## **Sevington Inland Border Facility**

### **Technical Note – Local Traffic Network and Highways**

Application Reference No: CROWN/2025/0000002

November 2025

Figure 2 : Preliminary Mitigation Layout on A20 Eastbound Approach

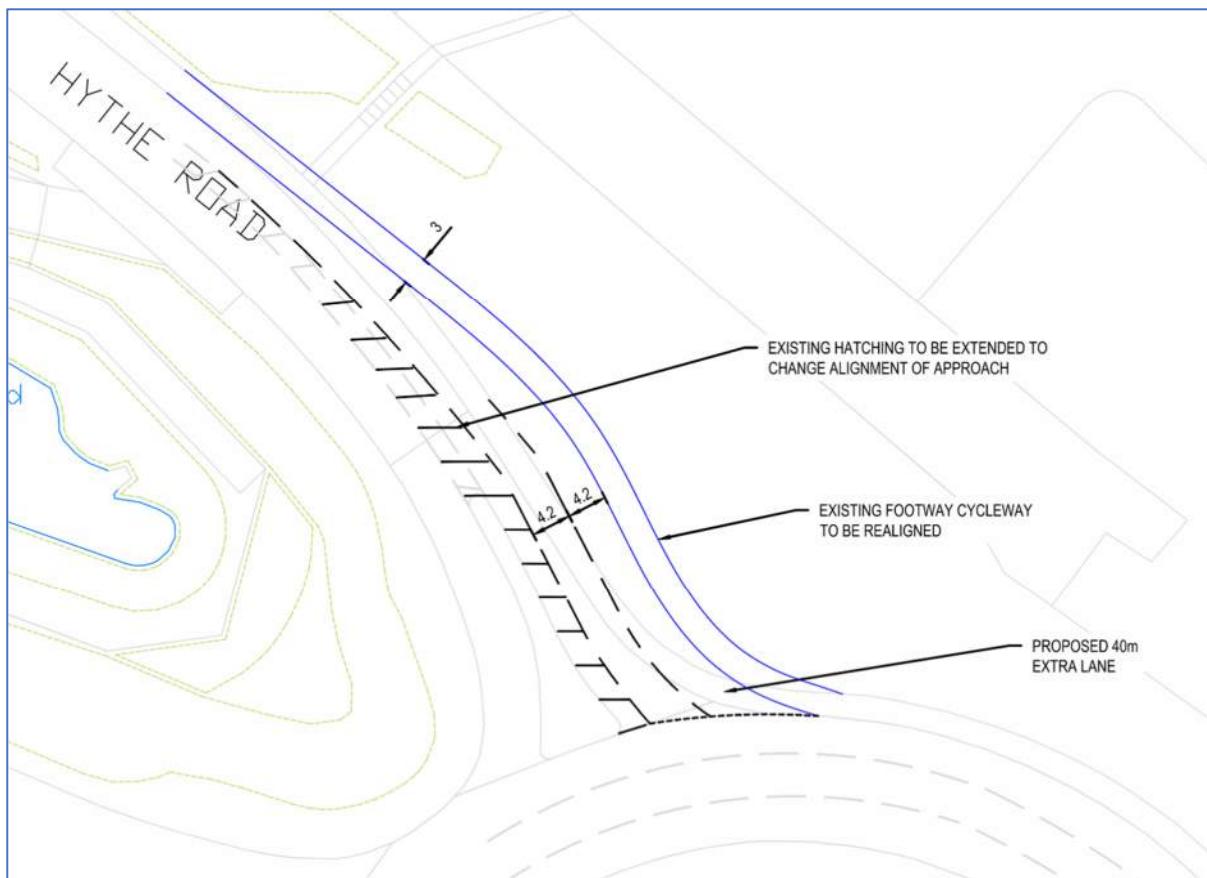
- 3.5. An initial preliminary option layout of this potential scheme was designed and submitted to KCC and NH on 5<sup>th</sup> November 2025 for comment. KCC noted the following regarding the changes to the A20 eastbound approach:

3.6. Based on these comments, a revised preliminary option layout of this potential scheme has been designed and an extract of the drawing shown below in Figure 2.

- A 40-metre long flare (second lane) that is 4.2 wide in its middle section, which is envisaged to serve traffic headed to the A20 eastern arm, has been added to the nearside of the approach and modelled in this format. This provides sufficient width for Heavy Goods Vehicles (HGVs) to travel in the lane and not conflict with traffic in the neighbouring lane, as shown by the swept path analysis undertaken of the 16.5m long articulated HGV attached at **Appendix A**.

- The existing 2.5m wide shared footway/cycleway has been relocated to the east to accommodate the widening of the carriageway for the additional approach lane.

3.8. It is considered that this preliminary design has been revised appropriately to address the comments from KCC.
